Subject: Zion Station Units 1 and 2
Commonwealth Edison's Response
to NRC Diagnostic Evaluation
NRC Docket Nos. 50-295 and 50-304

Response to Zion Station Diagnostic Evaluation Report

New Zion Station Operating Organization

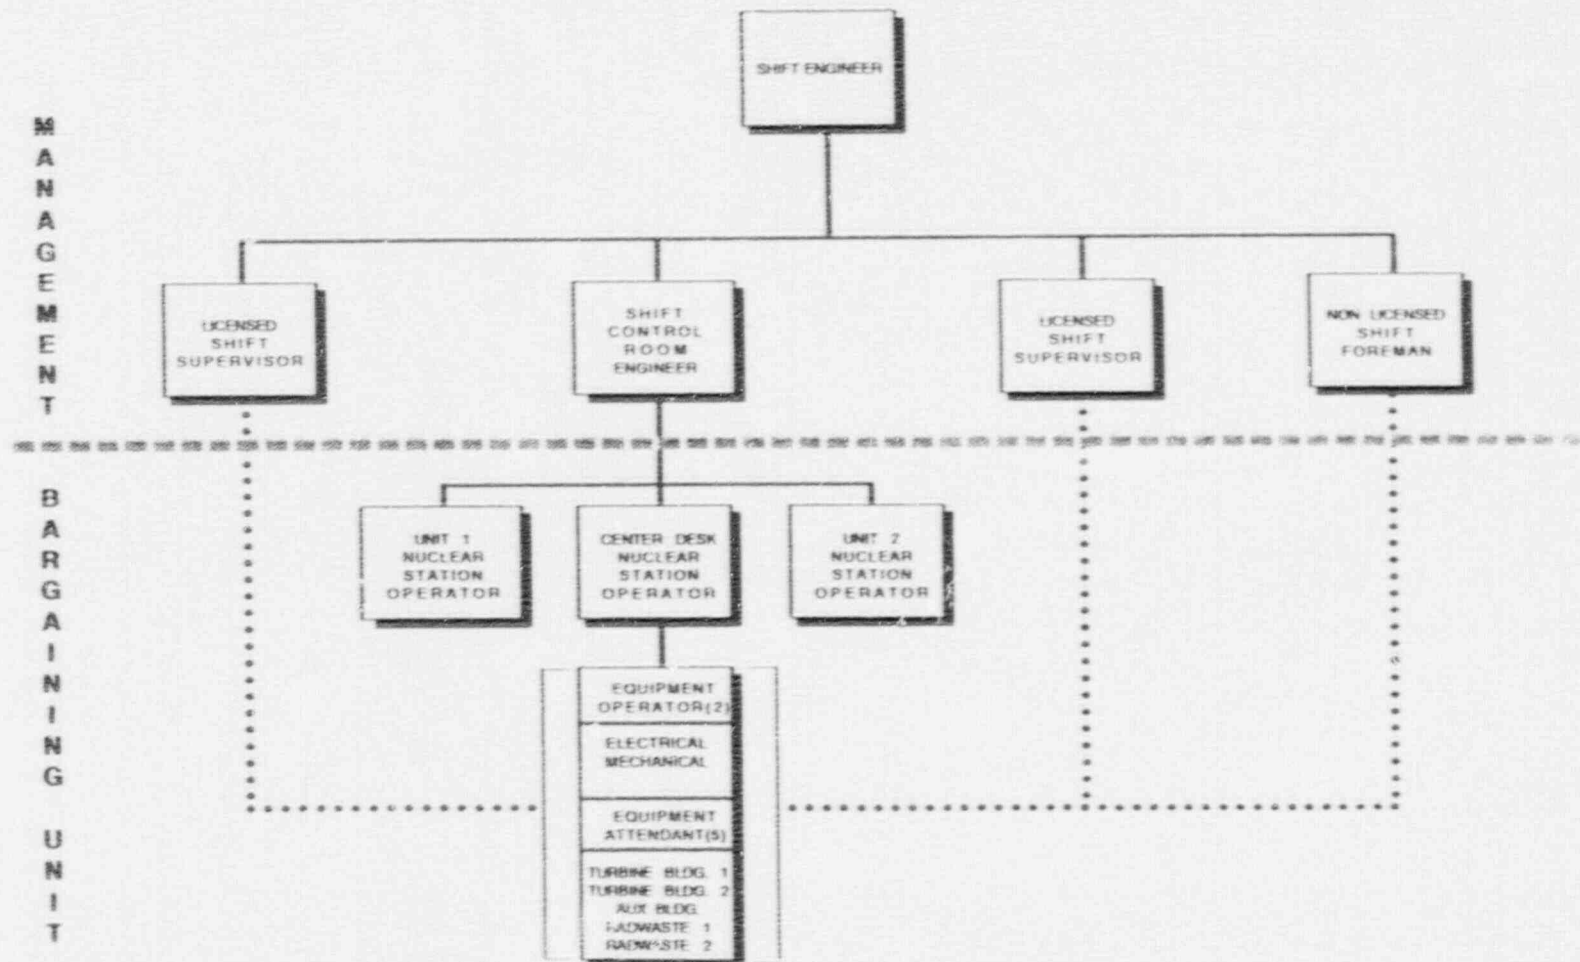
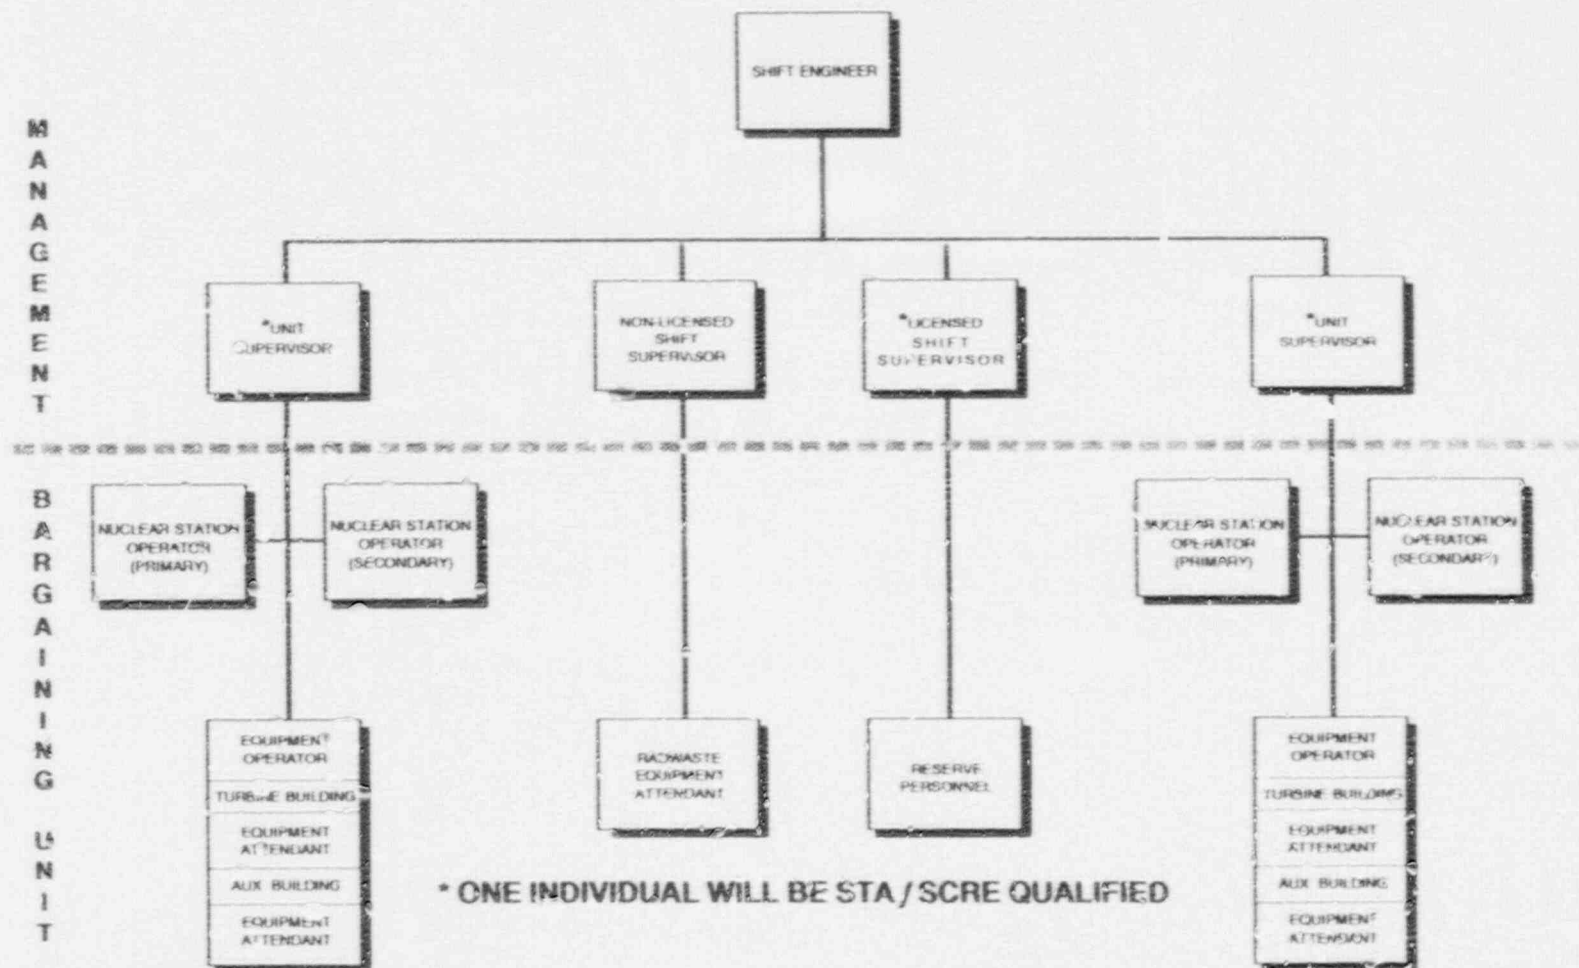
Zion Station has reorganized the control room to establish clear lines of authority and a strong supervisory presence within the operating shift organization while enhancing the concept of teamwork associated with unit-specific responsibilities. Figure 1 contains the previous control room organization chart and Figure 2 contains the revised control room organization chart depicting the changes that have been made.

Certain Administrative duties previously assigned to the Control Room Supervisor have been redistributed to allow the Unit Supervisors to focus on Shift Supervision. The Shift Technical Advisor (STA) function is performed by one of the unit supervisors or the licensed foreman as indicated in figure 2.

Commonwealth Edison believes that there are two elements involved in this issue. The first involved whether the previously existing organization allowed the Shift Control Room Engineers (SCORE) to be effective supervisors. As shown in Figure 2, Zion Station believes that the operating shift reorganization has improved the effectiveness of Shift Supervision.
